RE: DRAINAGE PLAN FOR THE SIGN CENTER  
SUBMITTED NOVEMBER 7, 1985 FOR BUILDING PERMIT APPROVAL  
(L-22/D38)

REF: REVISED DRAINAGE PLAN FOR THE SIGN CENTER AT 12999 COCHITI ROAD, SE  
(L22-D38) RECEIVED SEPTEMBER 12, 1985

REF: DRAINAGE PLAN FOR THE SIGN CENTER (L22-D38) RECEIVED JUNE 3, 1985

THE SIGN CENTER  
12999 Cochiti Road, S.E.  
Albuquerque, New Mexico

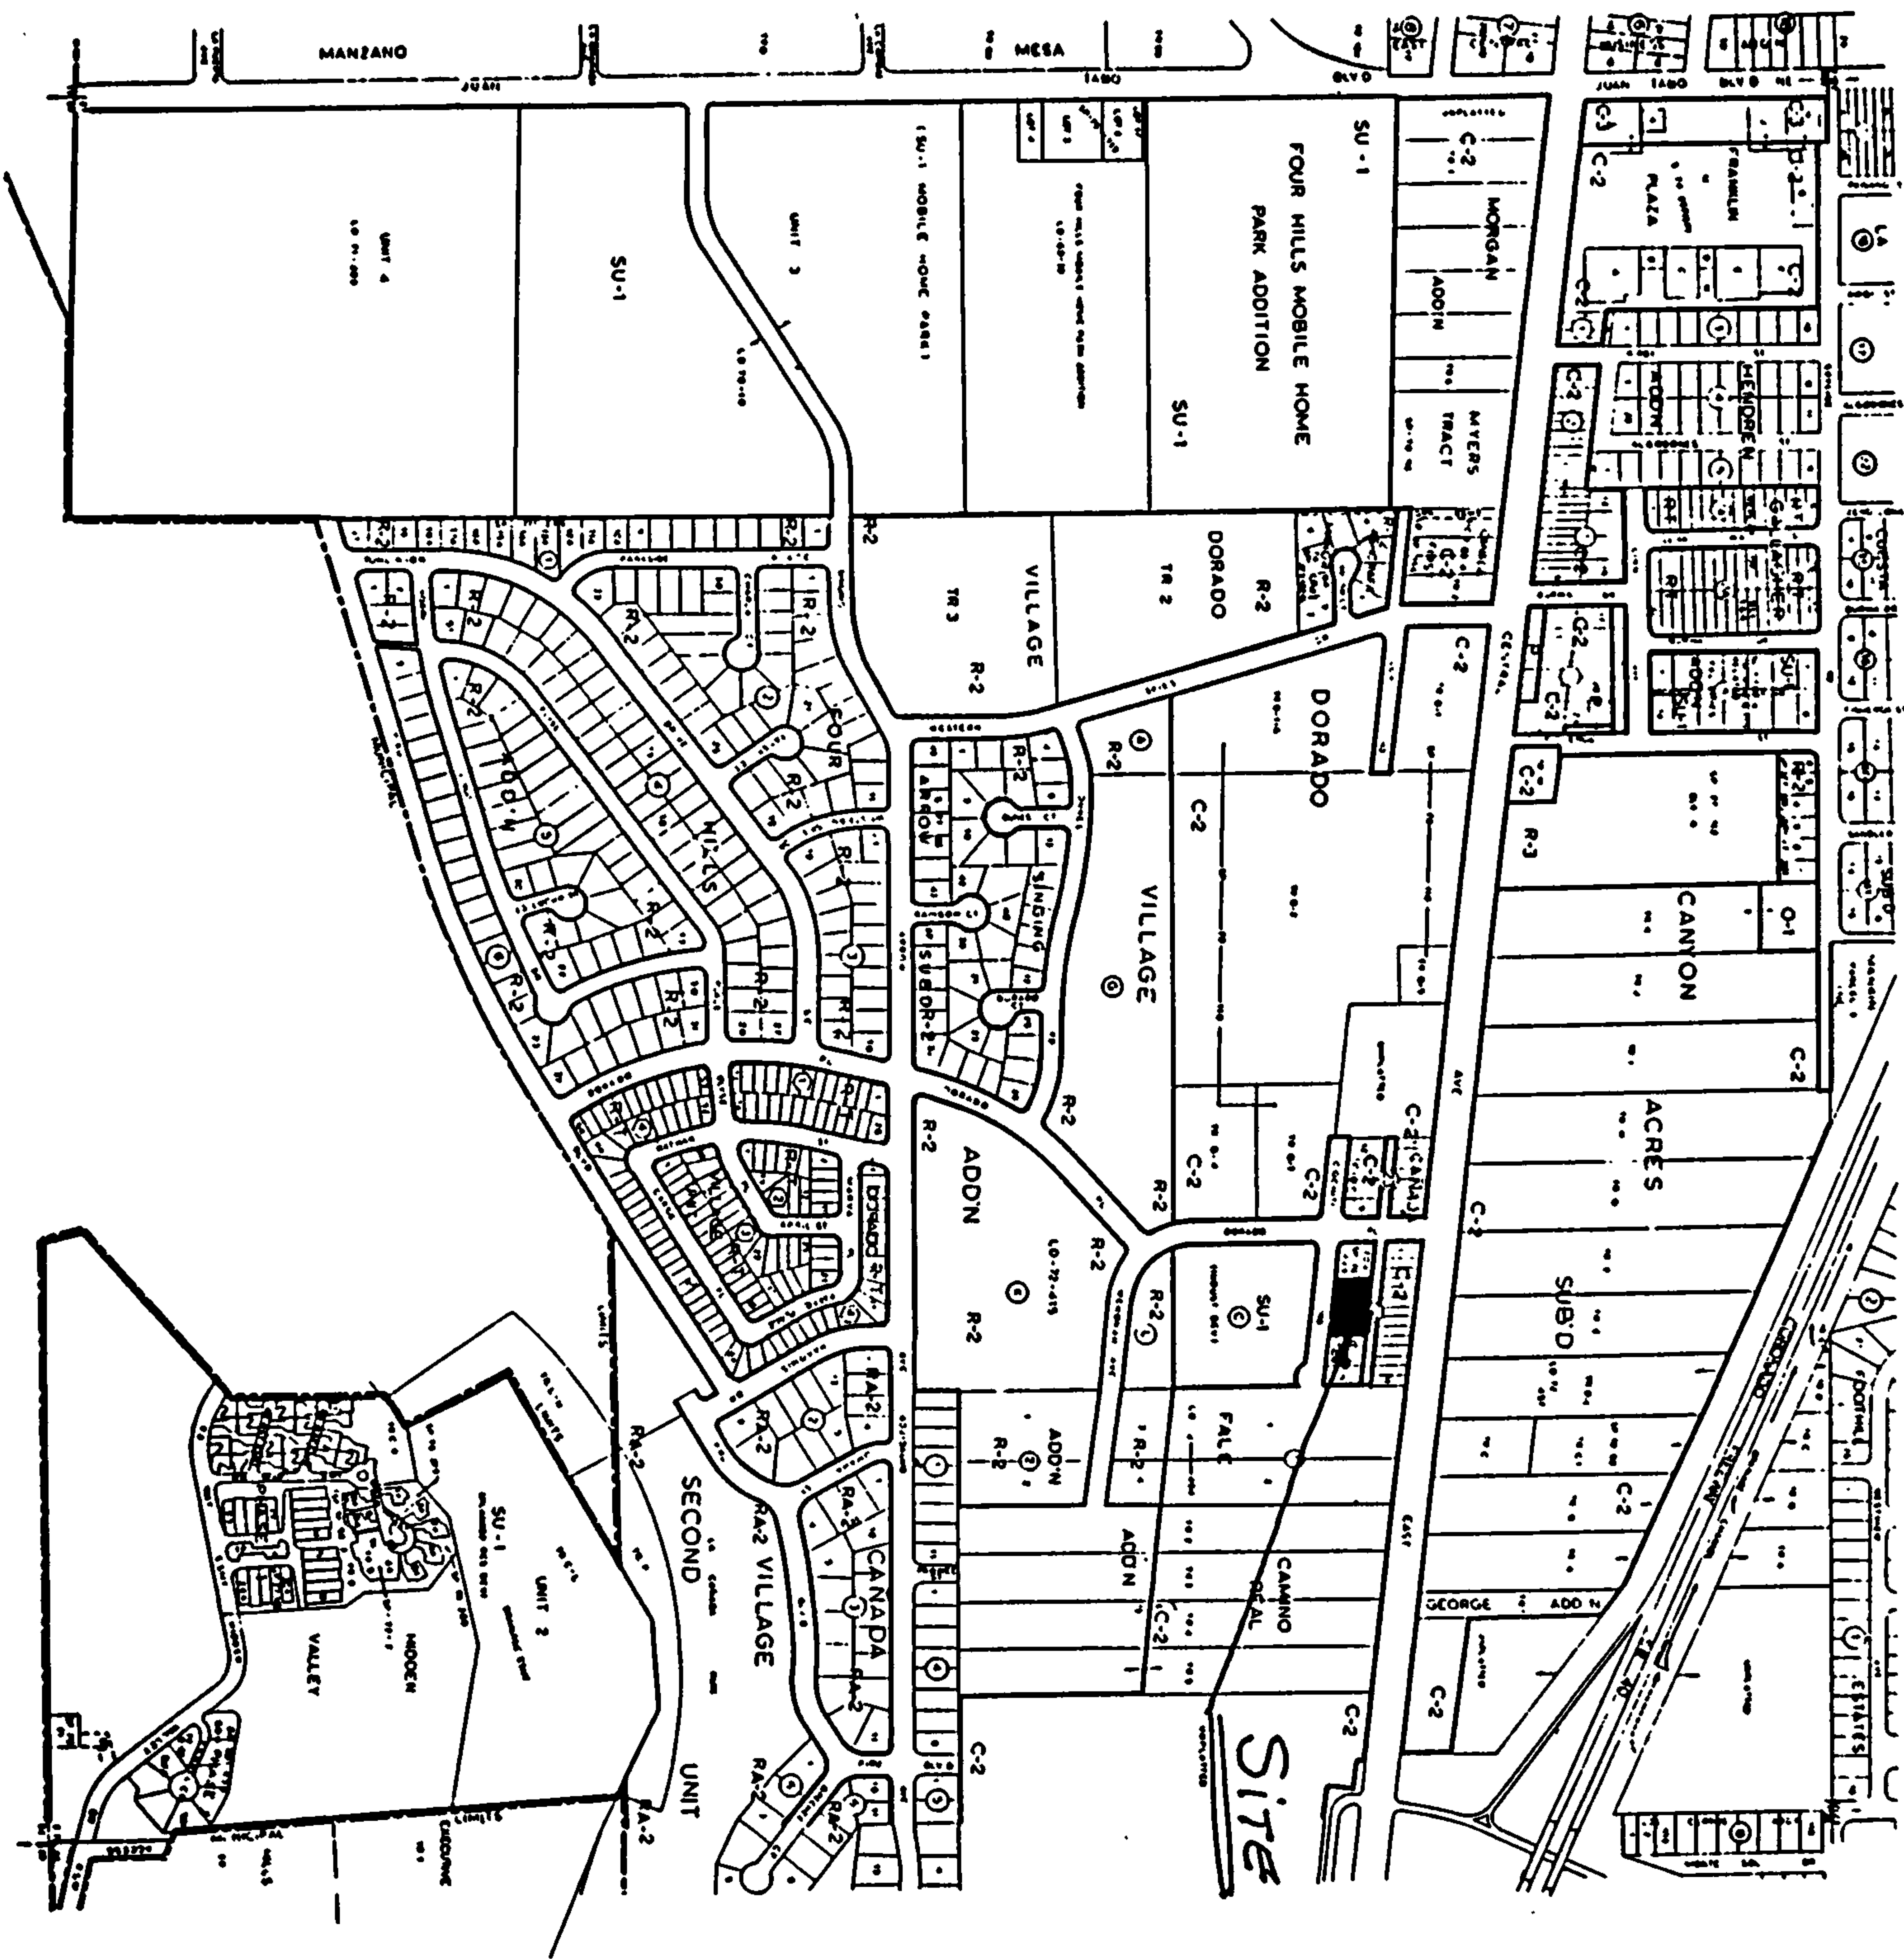
1. Per the DPM criteria, ponding within 15 feet of a structure is not allowed without an approved soils report.
2. Since the contractor does not have access to our files, the erosion control plan for the period of construction will need to be included on the plan.

1. Per the DPM criteria, ponding within 15 feet of a structure is not allowed without an approved soils report.
2. Since the contractor does not have access to our files, the erosion control plan for the period of construction will need to be included on the plan.
